# TM Textiles & Garments Ltd.

25 May 2014

# Observations

No fireproofing to steelwork

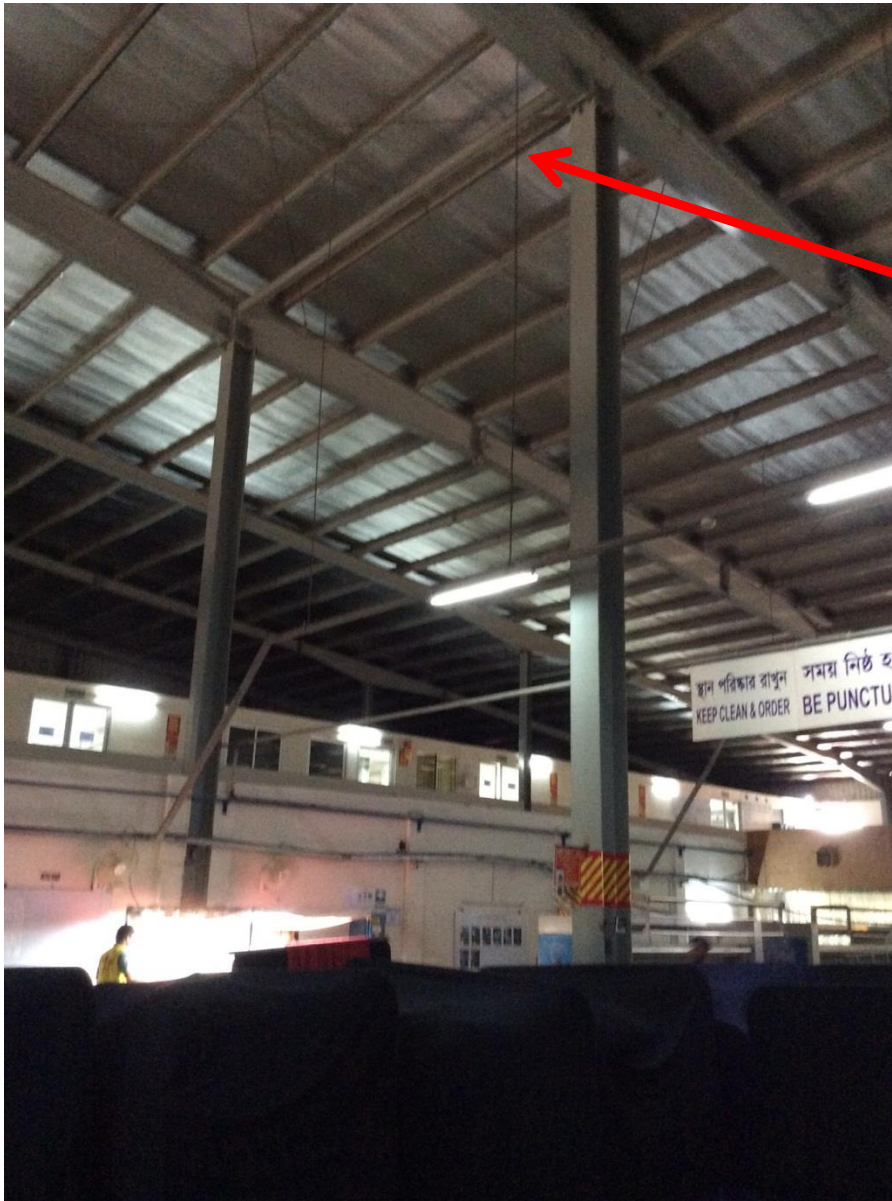
**There was no fireproofing of steelwork**

There was no fire protection on steel structures across the entire site .

Typical Roof structure type observed in garment building, knitting building and dyeing building

Item No.	Observation	Recommended Action Plan	Recommended Timeline
1	There was no fireproofing of steelwork	Building Engineer to assess the requirement for providing fire protection to the steelwork particularly in relation to the mezzanine structures and the 2 storey buildings	6-weeks
2	There was no fireproofing of steelwork	Fire protection works to the steelwork as deemed required by the Building Engineer are to be implemented on site. The Building Engineer is to inspect these works during the implementation stage and on completion to confirm that the works comply with the requirements.	6-months
3	Lateral Stability of the portal frame structures	The Building Engineer is to assess the lateral stability of the portal frames in all buildings in the direction perpendicular to the portal frames. This assessment should confirm or otherwise that the steel rope bracing and circular hollow sections provide sufficient resistance to lateral loading in this direction.	6-months

Construction works ongoing

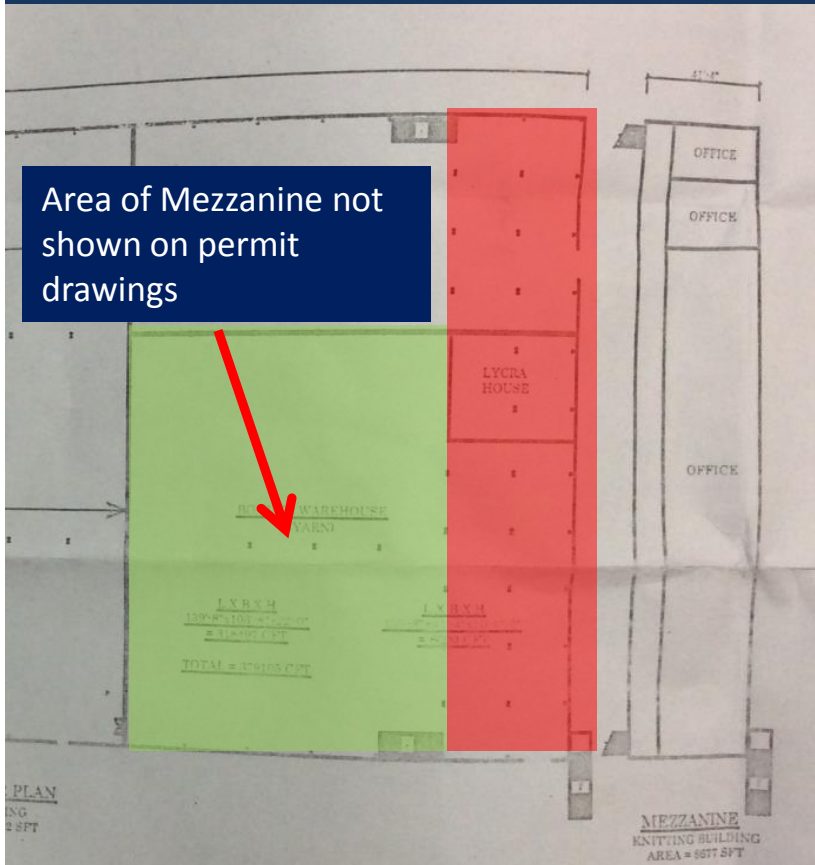
Some construction work was on-going, and not shown in building permits

Lift pit in new warehouse building

New lift pit in knitting building

4	Lateral Stability of the portal frame structures	The Building Engineer is to monitor the implementation of any measures deemed necessary on site following the assessment noted above.	6-months
5	Construction works on-going	It was noted on site that construction works are on-going in relation to a new Warehouse, a new scissor lift in the Knitting Building and a new section of mezzanine in the Knitting Building. The Building Engineer is to carry out a structural assessment of these works to confirm their structural adequacy and where relevant to confirm that the existing building has sufficient structural capacity to cater for these changes and additional loading.	6-weeks
6	Construction works on-going	The Building Engineer is to monitor the implementation of any measures deemed necessary on site following the assessment noted above.	6-months

Water tank loading on the roof of Medical and Day Care Building

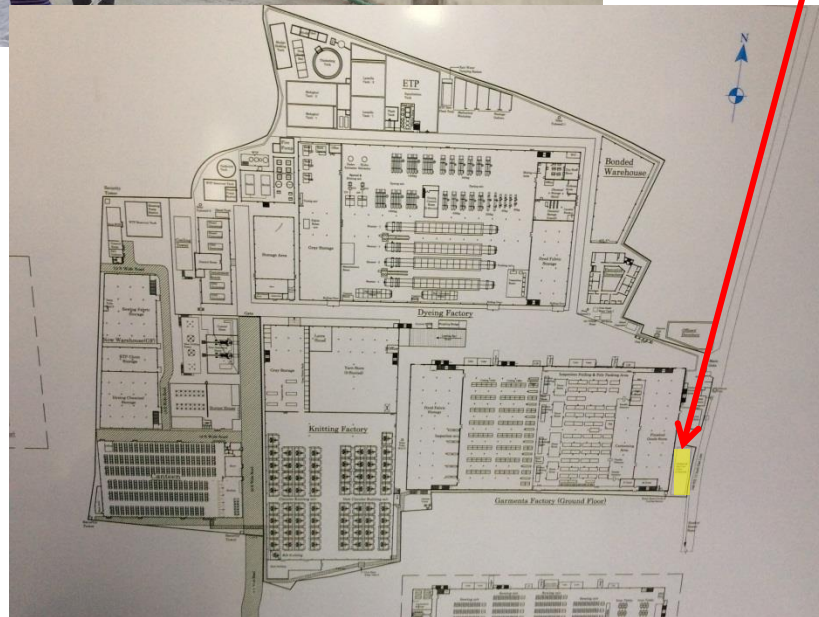
Water tanks positioned above the stair core on Medical Centre Building

Item No.	Observation	Recommended Action Plan	Recommended Timeline
7	Storage Loading on the new mezzanine in the Knitting Building	The capacity of the mezzanine structure is to be assessed by the Building Engineer to confirm that the mezzanine structure is designed to carry the loading from the storage noted.	6-months
8	Storage Loading on the new mezzanine in the Knitting Building	Produce and actively manage a loading plan for all elevated floor plates for all buildings within the factory complex giving consideration to floor capacity and column capacity.	6-months
9	Water Tank loading on the roof of Medical and Day Care Building	The capacity of the roof structure is to be assessed by the Building Engineer to confirm that the roof structure is designed to carry the loading from the water tanks noted.	6-months
10	Water Tank loading on the roof of Medical and Day Care Building	Produce and actively manage a loading plan for all elevated floor plates for all buildings within the factory complex giving consideration to floor capacity and column capacity.	6-months

Change in column section size in the new warehouse

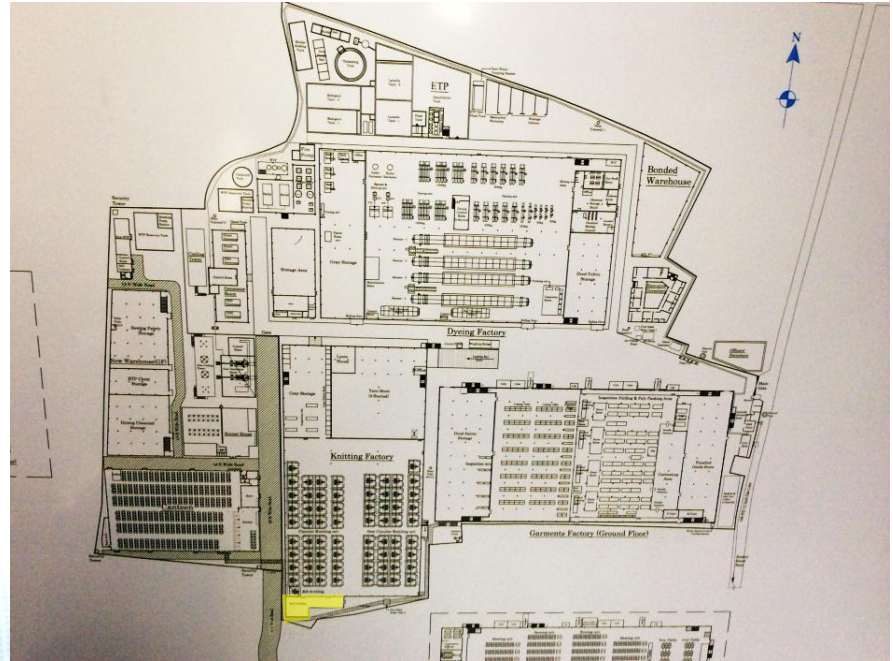
Change in column size was observed towards top of column in the new warehouse building

Item No.	Observation	Recommended Action Plan	Recommended Timeline
11	Change in column section size in the new Warehouse	The capacity of the reduced column section is to be assessed by the Building Engineer to confirm that it is structurally adequate.	6-months
12	Change in column section size in the new Warehouse	The Building Engineer is to monitor the implementation of any measures deemed necessary on site following the assessment noted above.	6-months
13	Possible future extension works noted to Knitting Building	If any additions to the building structure are proposed, the Building Engineer shall provide calculations showing the structural adequacy of all columns taking into account any additions to the existing structure, the loading and as built structure, including in-situ concrete strength testing.	6-months
14	Inconsistencies between the permit/ structural drawings and the as-built structures	Building Engineer to check, collect information and produce accurate and fully complete as-built documentation.	6-months

Inconsistencies between permit drawings and as-built structures

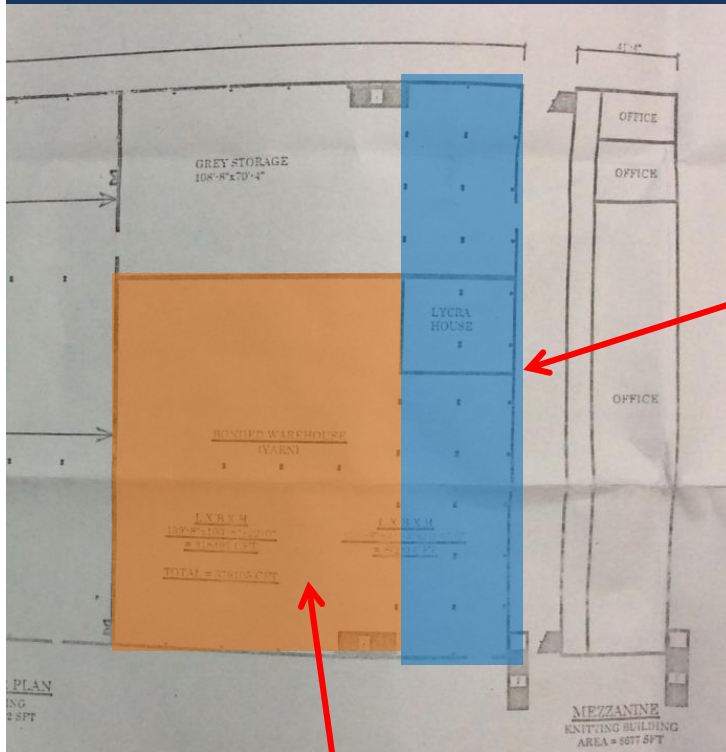
The mezzanine area within the knitting building was significantly larger than the permit drawings suggested. Steelwork had been provided beneath the extension to support this, although this was also excluded from the structural drawings.

Extent of mezzanine according to building permit

Additional mezzanine area observed

New warehouse as proposed in plan

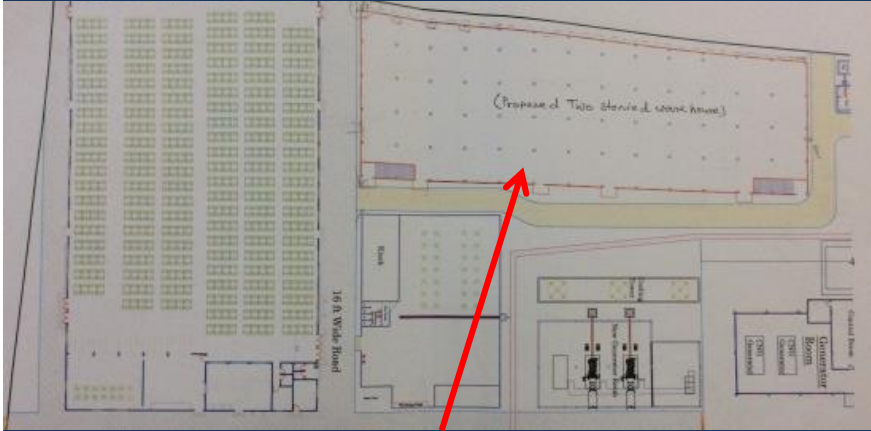
No permit had been obtained for the new warehouse building by the day of inspection

Inconsistencies between permit drawings and as-built structures

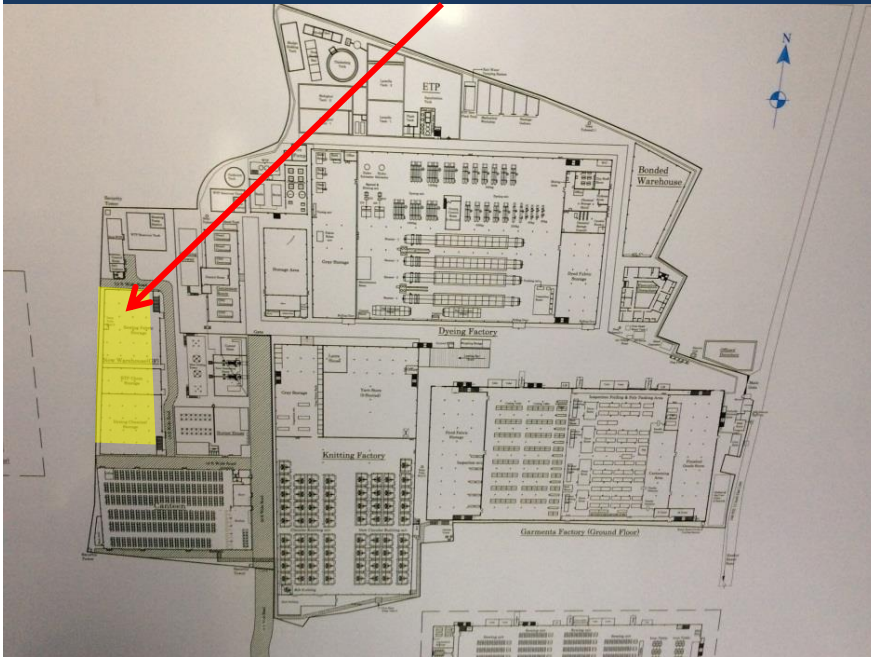
Level 01 of New Warehouse Building

Ground Floor of New Warehouse Building
